**RE: Response to Approval with Modifications
[REVISED] SWMU-1 Corrective Measures Implementation Work Plan
Western Refining Southwest LLC, Gallup Refinery
McKinley County, Gallup, New Mexico
EPA ID# NMD000333211
HWB-WRG-21-016**

**New Mexico Environment Department (NMED) To Western Refining Southwest LLC (D/B/A Marathon Gallup Refinery [Refinery])
Approval with Modifications Letter "SWMU-1 Corrective Measures Investigation Work Plan" (April 4, 2024)**

ATTACHMENT B
BULKHEAD OFFLOADING RAMP DETAIL

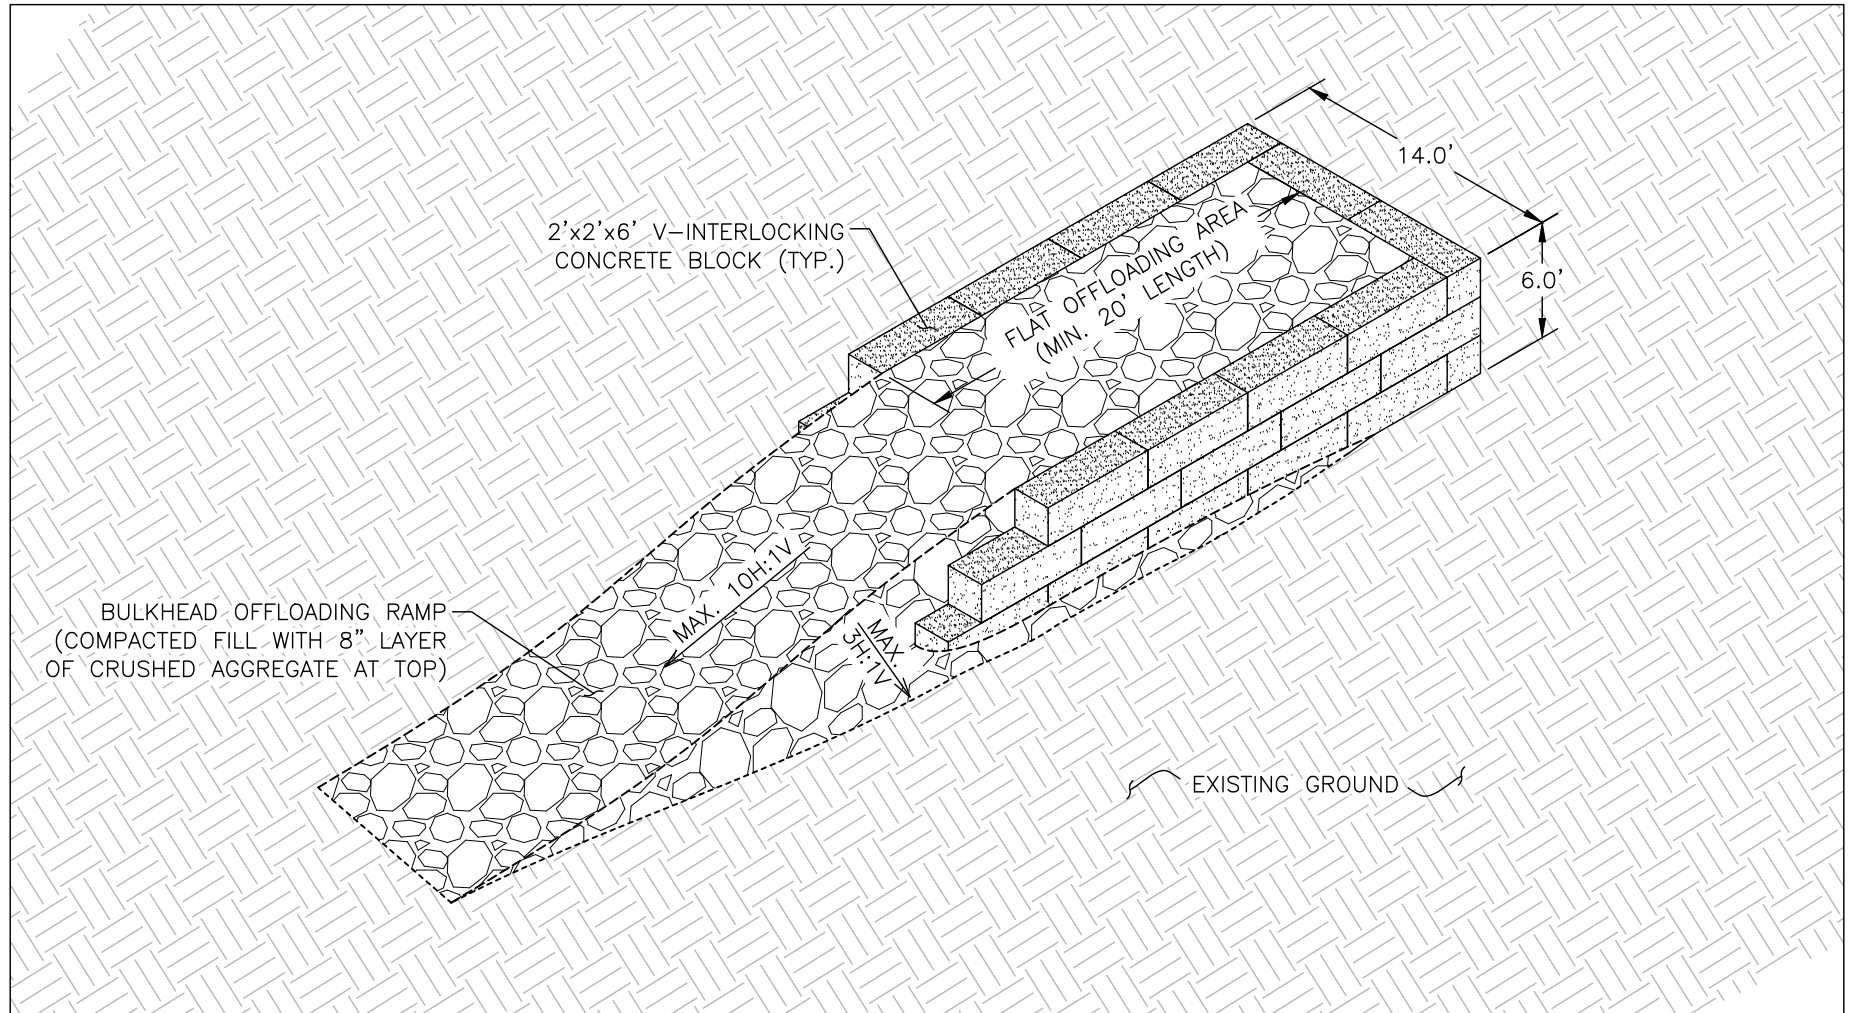
NMED Comment	Western Response
Comment 7: Section 4.3 (Waste Excavation, Loading and Stockpiling) of the Waste Stabilization and Excavation Plan & Transportation Plan included in Appendix G, page 8 of 12, states, "[a] bulkhead, approximately six feet high will be constructed using concrete blocks. A ramp will be constructed that leads to the bulkhead approximately four feet high. The ramp will be constructed so that the truck is level from front to back during the dumping of the waste. The truck will back up to the bulkhead and dump the waste. This will prevent the tires of the truck from contacting waste material. A concrete pad will be constructed in front of the bulkhead to allow the loader to pick up the waste for transfer to a stockpile. This will eliminate damage to the sacrificial cover and easy removal of all the waste." It is difficult to understand the loading process from the text. Provide the schematics for the bulkhead with the response letter and the remedy completion report. The schematics need not to be scaled. This comment is intended to facilitate understanding of the process only, rather than to evaluate engineering design	Response 7: A schematic of the bulkhead is included in Attachment B. The bulkhead is intended to keep the haul trucks off the staging area liner to prevent damage to the liner.
